P.O.A.D.P. PLAN
for
BECKER RANCH ESTATES

SUBJECT: Becker Ranch POADP Level I T.I.A.

POADP # 631

The City Staff Development Review Committee has reviewed Becker Ranch Subdivision Preliminary Overall Area Development Plan # 631. Please find enclosed a signed copy for your files. Although your plan was accepted, please note the following:

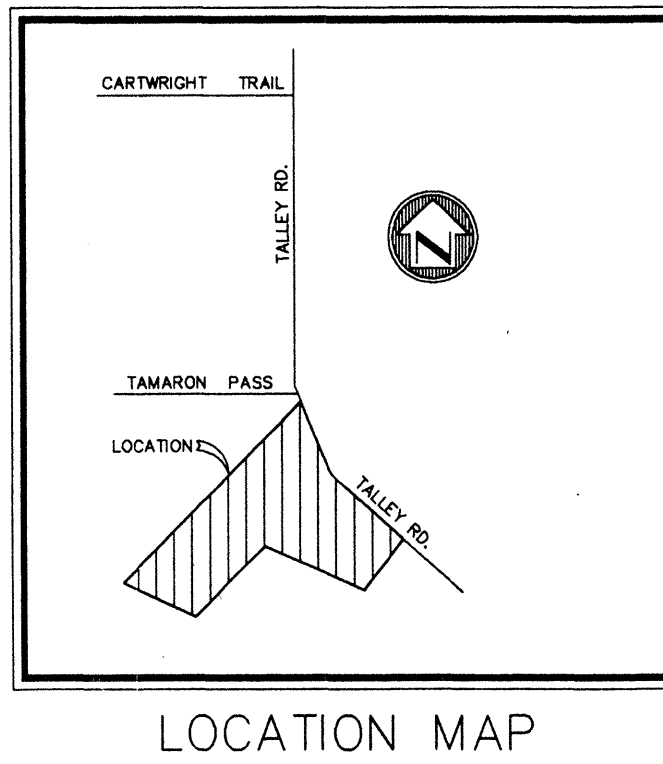
- Based on the topography, a Flood Plain Study and drainage review will probably be required during the platting process.
- Need flood study to determine BFE. LOMR request to FEMA may be required, and the ROW must be maintained outside the 100 year flood plain limits.

- Remaining lot sizes after the flood plan revisions must be greater than .5 acres, i.e. there must be at least half an acre outside the flood plain for a house and an On Site Sanitary Sewer Facility construction.

- A variance will be required at the time of plat submittal, for residential lots fronting on a major thoroughfare.
- In consideration of public safety and convenience, excessive grades by reason of topography should be avoided in street layouts and arrangements.

- This development will need to comply with tree preservation ordinance #85262. For information about these requirements you can contact Building Inspections at 207-7102.

- It will be expected that you will plat all of the property depicted in your POADP, to include: floodpains, drainage areas and open space.
- The entrance at Tally Road needs a 25' cutback.

- Access will need to be provided to adjacent property owner Isabell Boehme.
- I would encourage you to work closely with the school district, so that they can plan accordingly.
